**Corstorphine Connections – Phase 2**  
Stage 1 and 2 Road Safety Audit  
City of Edinburgh Council

September 2023

Client	City of Edinburgh Council
RSA team organisation	Atkins
Report title	Corstorphine Connections – Phase 2 Stage 1 and 2 Road Safety Audit
Client Reference	-
Atkins reference	8003-676

**SHEET NUMBER**  
60636731-SHT-C-P2-LTN-0703

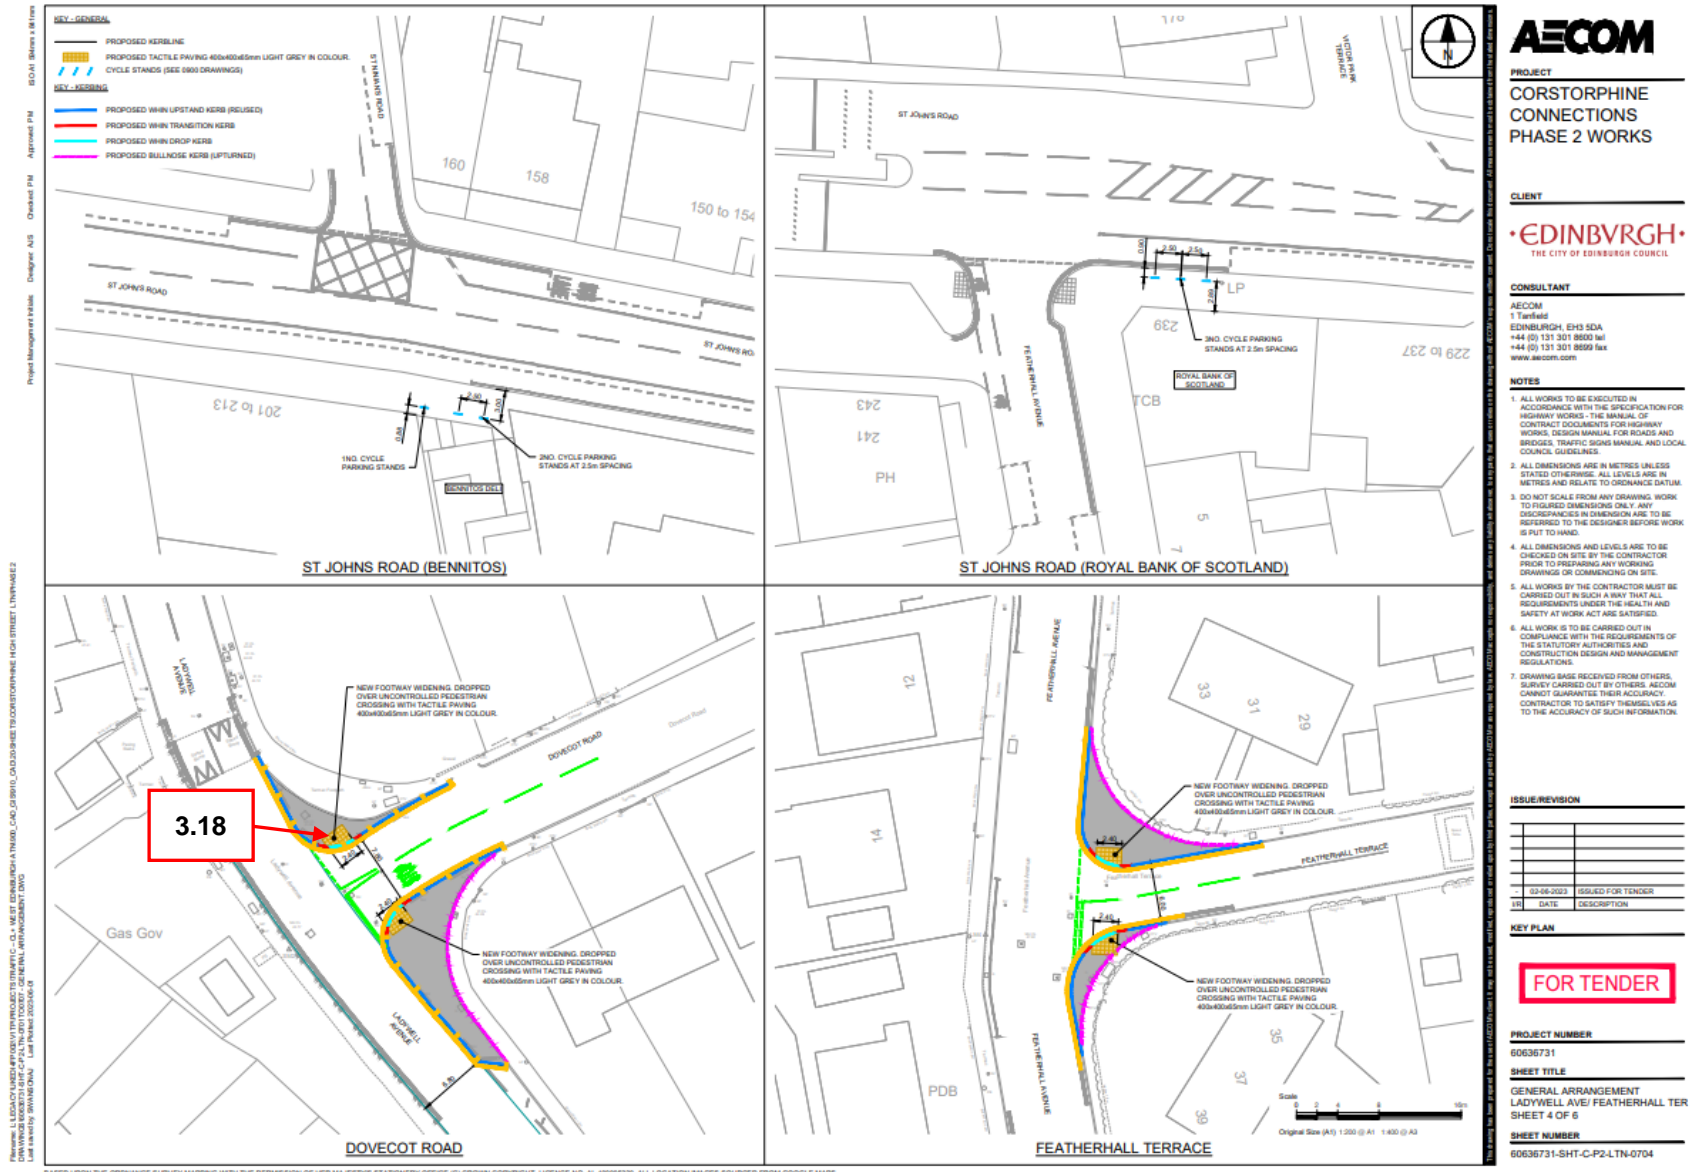
<b>Problem:</b>	<b>3.15</b>
<b>Location(s):</b>	Saughton Road North (east side), entrance and exit to the shops
<b>Drawing(s):</b>	60636731-SHT-C-P2-LTN-0703
<b>Summary:</b>	Risk of vehicle conflicts and collisions due to the introduction of two-way traffic.

It was observed during the site visit that the accesses to the minor road serving the shops located on the east side of Saughton Road North operates as a one-way, with vehicles entering to the north and exiting from the south. The plans indicate the installation of two-way give way markings at both accesses. It is anticipated that two-way vehicular traffic at these accesses and across the minor road will result in vehicle conflicts as drivers may not expect opposing movements. Additionally, the southern access is narrow, and vehicles were observed encroaching what would be the opposing running lane in order to manoeuvre out of the minor road. This could result in collisions.

<b>Problem:</b>	<b>3.16</b>
<b>Location(s):</b>	Saughton Road North (west side), adjacent to shops
<b>Drawing(s):</b>	60636731-SHT-C-P2-LTN-0703
<b>Summary:</b>	Restricted visibility may result in crossing pedestrians being struck.

A buildout and uncontrolled crossing facility is proposed between the existing parking spaces located outside the shops on the west side of Saughton Road North. There is a risk that parked vehicles either side of the buildout will restrict intervisibility to/from the crossing for pedestrians and approaching vehicles. This increases the risk of pedestrians entering the carriageway into the path of an oncoming vehicle and being struck.

<b>Problem:</b>	<b>3.17</b>
<b>Location(s):</b>	Saughton Road North, north of Broomfield Crescent
<b>Drawing(s):</b>	60636731-SHT-C-P2-LTN-0703
<b>Summary:</b>	Tree canopy creating dark spots and potentially reducing street lighting illumination at the footway and crossing facility.

During the site visit it was observed that tree canopies on the west side of Saughton Road North were creating dark spots over the western footway and at the pedestrian refuge island north of Broomfield Crescent. As a result, pedestrians were difficult to see, and the reduced visibility increases the risk of pedestrians crossing at the refuge island being struck.

3.15	Risk of vehicle conflicts and collisions due to the introduction of two-way traffic.	It is recommended that the one-way system is formalised.	The operation of the car park has been maintained, with no changes as part of our proposals. Additionally, the car park is privately owned and no formal control of enforcement would be possible.	As per design organisation's response	No action

3.16	Restricted visibility may result in crossing pedestrians being struck.	It is recommended that sufficient visibility is provided at the crossing facility	Visibility checked against 20mph SSD @ 25m. We confirm that both crossing points are suitable.	As per design organisation's response	No action

3.17	Tree canopy creating dark spots and potentially reducing street lighting illumination at the footway and crossing facility.	It is recommended that the tree canopies are cut back to ensure sufficient illumination is provided and to remove the dark spot observed.	Problem noted and accepted - Active Travel to raise with relevant internal department for consideration	As per design organisation's response	Active Travel team to raise with relevant internal department for consideration.

**Problem 3.23 refers to the absence of School Street signage at Tyler's Acre Avenue**

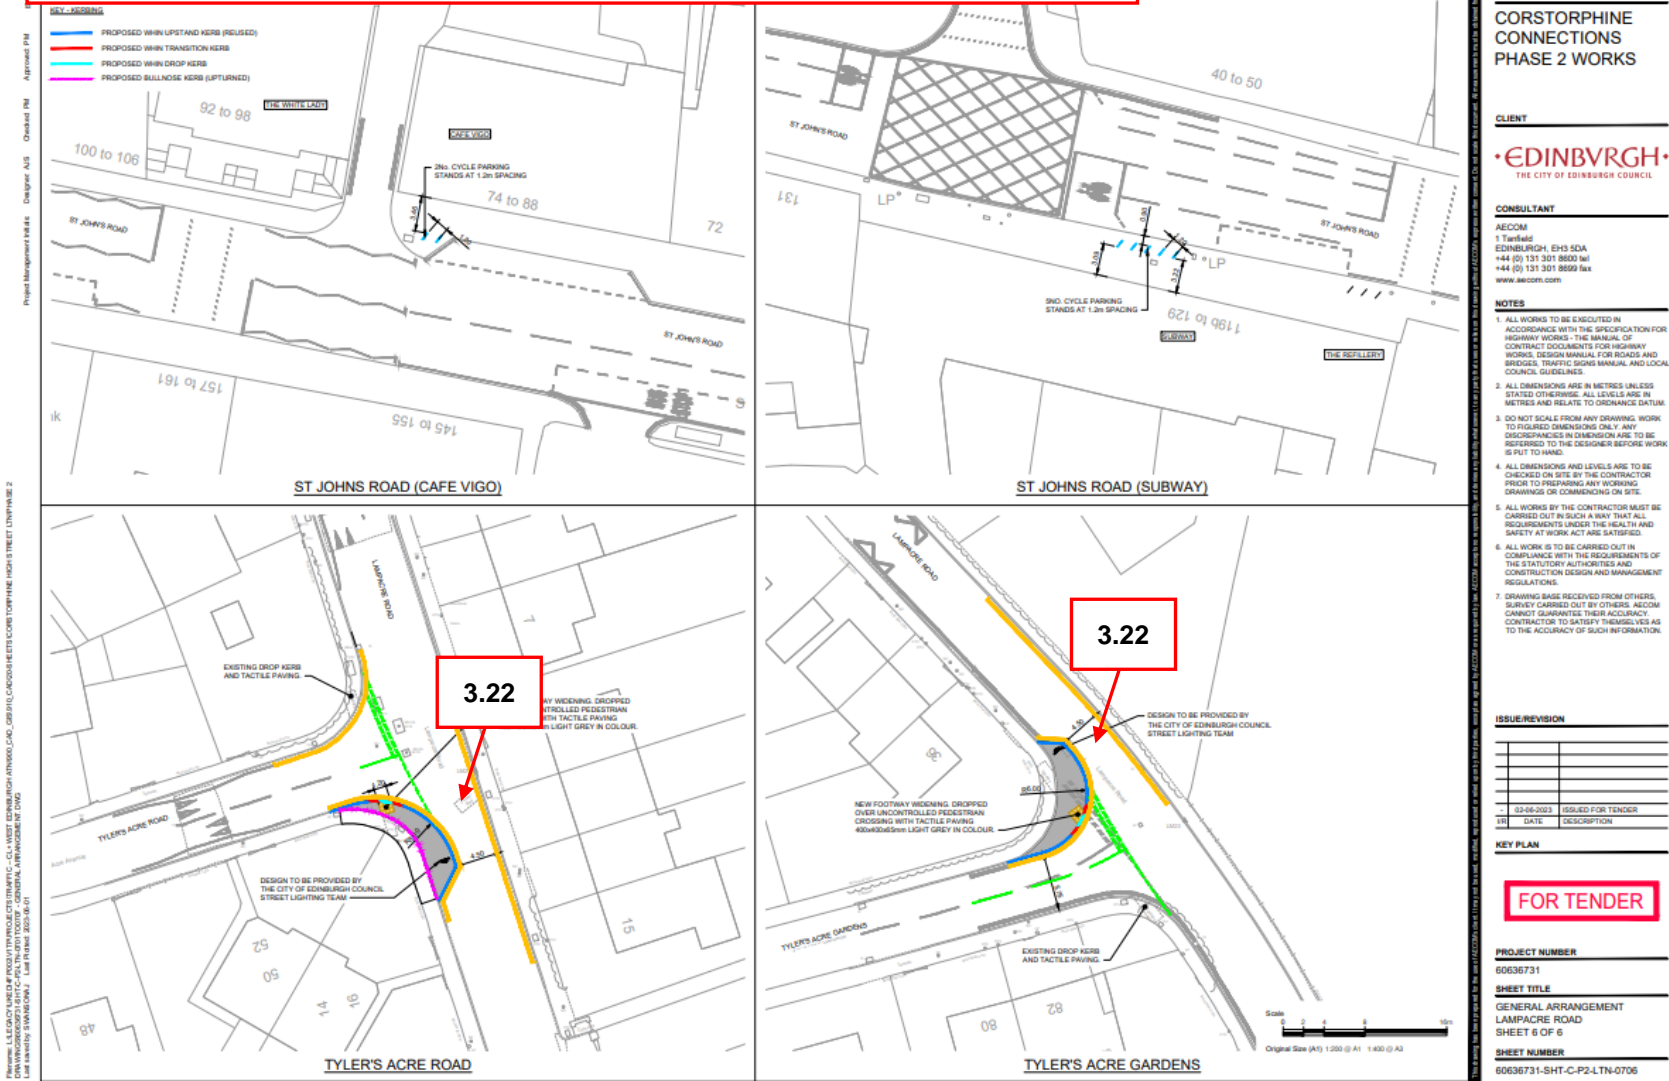
<b>Problem:</b>	<b>3.23</b>
<b>Location(s):</b>	Lampacre Road, at Carrick Knowe Primary School
<b>Drawing(s):</b>	60636731-SHT-C-P2-LTN-0706
<b>Summary:</b>	Risk of unpermitted vehicle movements occurring due to absent School Street signage.

School Street signs are proposed at the junctions of Lampacre Road at Tyler’s Acre Road and Tyler’s Acre Gardens to restrict vehicles movements along Lampacre Road at the start and end of the school day. Tyler’s Acre Avenue, which is located between the two junctions concerned connects Saughton Road North to Lampacre Road. The absence of School Street signage at Tyler’s Acre Avenue will give rise to vehicles entering the proposed School Streets scheme, which increases the likelihood of road user conflicts and potentially collisions as pedestrians and cyclists may not expect the anticipated volumes inadvertently travelling at Lampacre Road.

It is recommended that an additional School Street sign is installed.

3.22	Risk of side swipe collisions occurring as vehicles try to manoeuvre simultaneously.	It is recommended that a priority one-way working is installed on the approaches to the proposed buildouts.	The streets are within a quiet residential neighbourhood with low volumes and speeds. The locations of the buildouts were recommended in consultation with the Council's Road Safety team who manage the proposed school streets signs. The buildout is intentionally within the carriageway to help aid enforcement.	As per design organisation's response	No action
3.23	Risk of unpermitted vehicle movements occurring due to absent School Street signage.	It is recommended that an additional School Street sign is installed.	Problem noted and accepted - Tyler's Acre Avenue is to have a School Street sign installed	As per design organisation's response	School Street sign to be installed
